Turbocharger Replacement 830323-5006S / 873767-5001S

GTD1446VZM
VW 2.0L

04L253014L / 04L253014M

830323-5006S**873767-5001S****NEED TECHNICAL SUPPORT?**

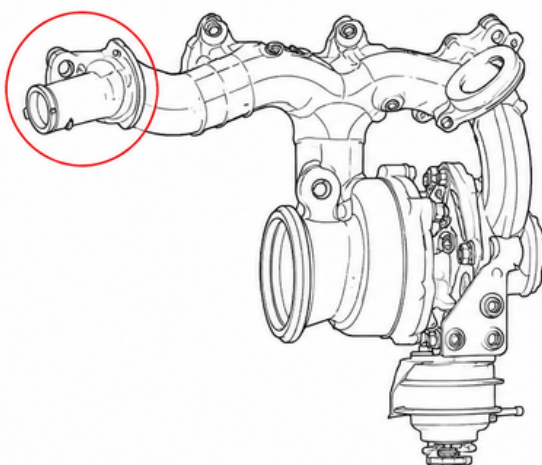
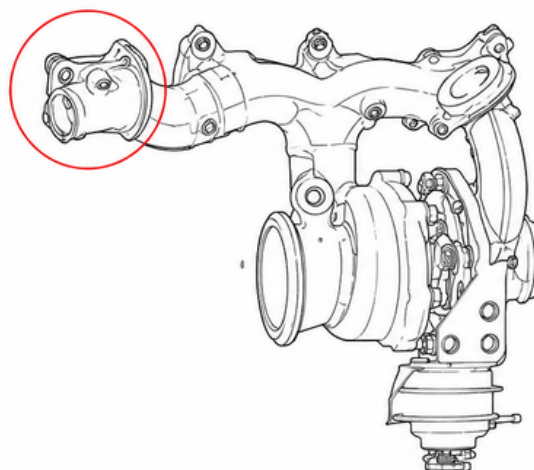
Turbocharger 830323-5006S has been superseded by 873767-5001S.

Although 873767-5001S is the correct replacement, it is not a direct service replacement.

The EGR pipe flange position on the turbine housing differs, so the images below should be used to identify the correct configuration before installation.

If replacing 830323-5006S, please refer to page 2 before ordering or installation.

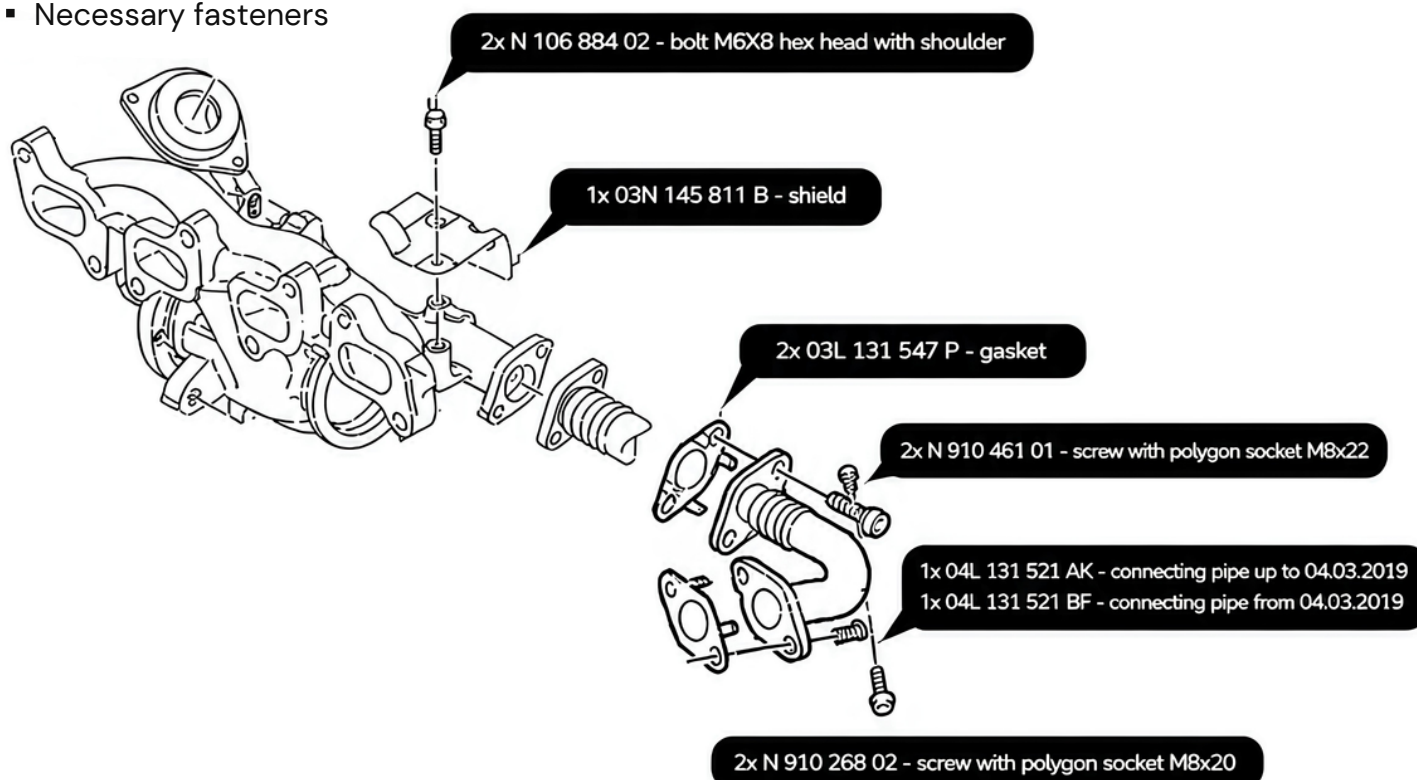
To replace turbocharger 830323-5006S you need to order the following:

Turbocharger 873767-5001S

From franchised VW dealer

- EGR pipe
- Gaskets
- Heatshield
- Necessary fasteners

Always verify the part number and the connecting pipe design before ordering or fitting. When replacing turbocharger 830323-5006S please ensure the EGR pipe flange position matches your requirements.
